6L6 Final Stage

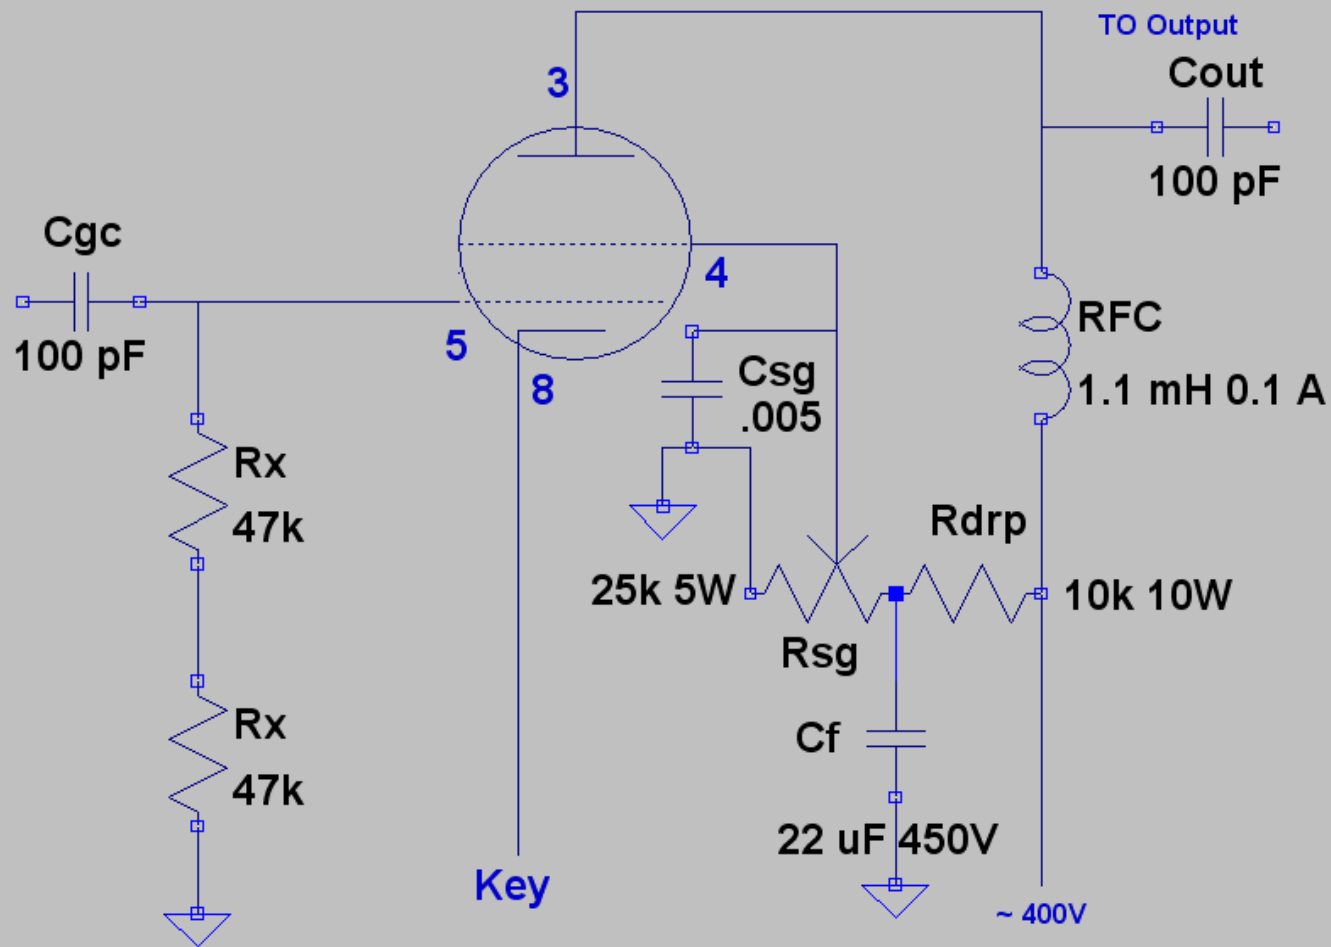
Below are some simple mods if you keep the choke circuit. The fuse in series with the Surge resistor is 2 amp fast blow ceramic that has an arc "quenching" powder in it to prevent what Carl described.

I did some further analysis on LT Spice and as you can see on the first page of the attachment, the choke's resistance causes the grid bias to increase as grid current goes up, such as on SSB peaks.

As you can see, with a 5.1 volt zener as Heath currently has, the total bias get very close to 1 volt at times. In my view, this is too low a total bias.

Bias Zeners: Contrary to what was posted, 7.5 Volt to 15 Volt 10 Watt zeners are the norm for SSB and AM operation. In fact, Eimac at one time stated that biases up to 15 volts would be appropriate for 3-500Z's in cathode driven linears.

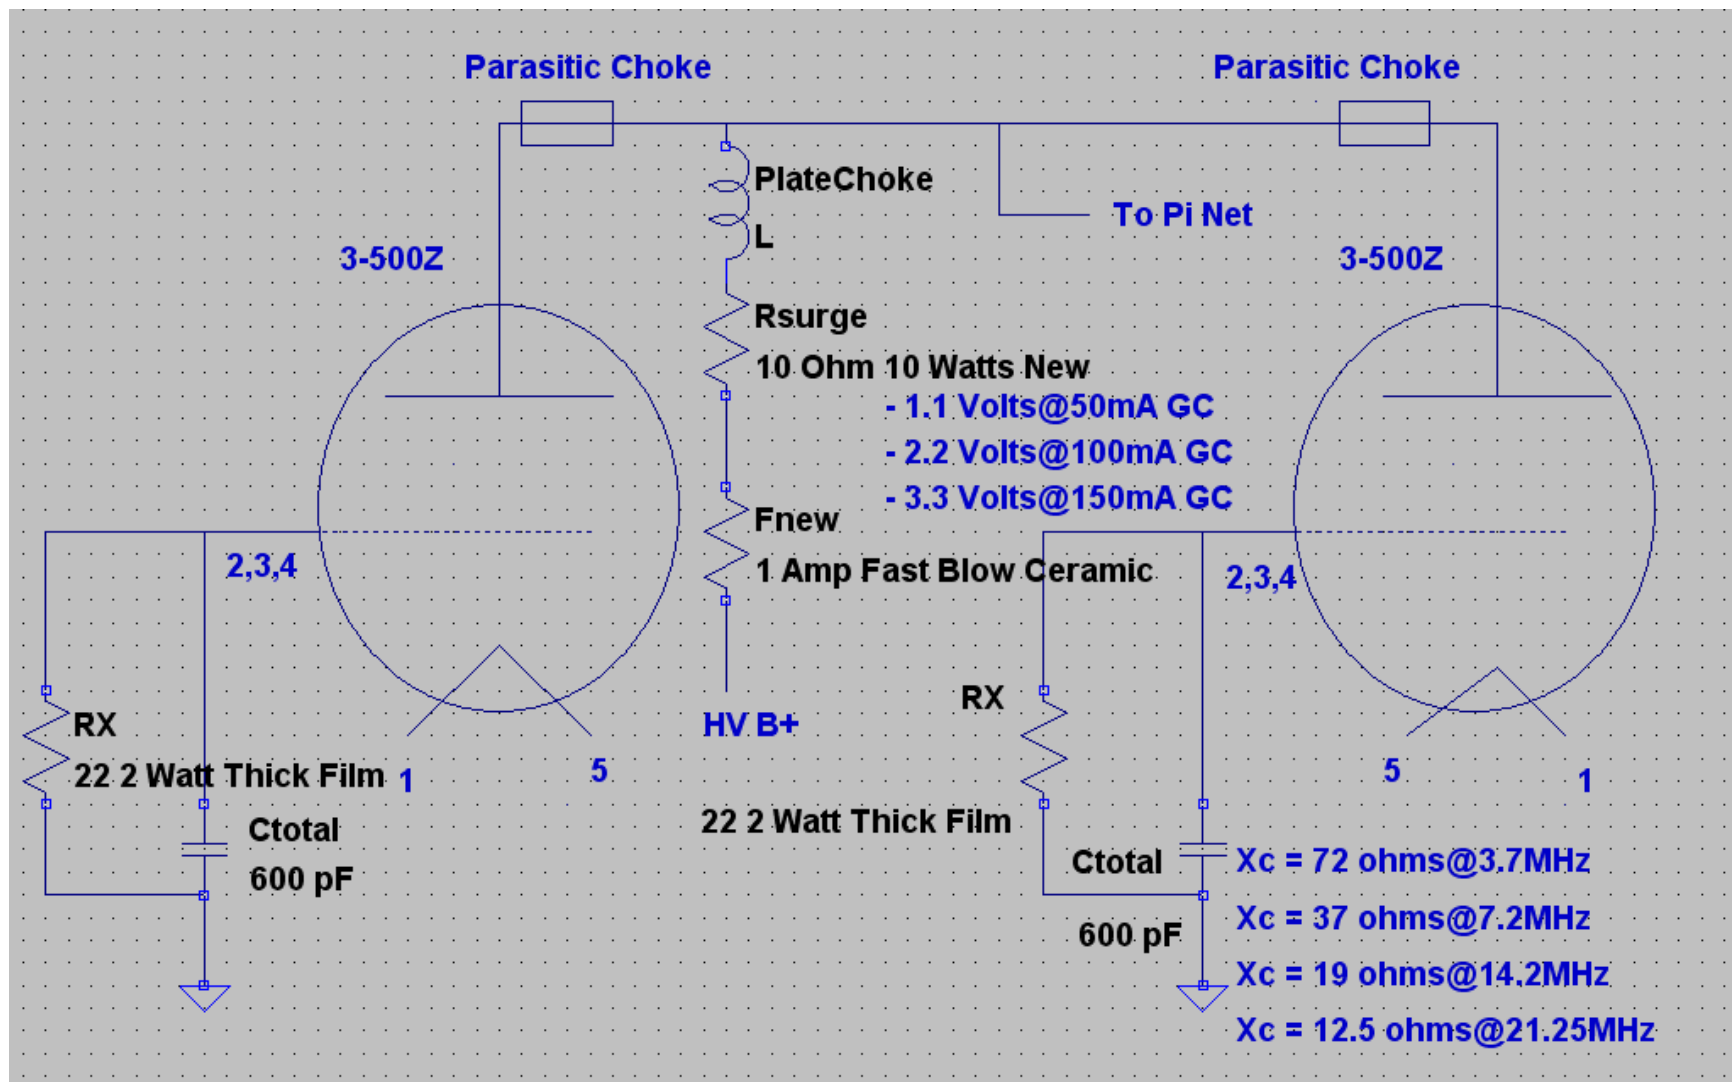
Anyway, on the second page, I replaced the chokes with 22 ohm, 2 Watt Thick Film resistors and the biases are still pretty close. So if chokes ever get into short supply, then this could be an option.
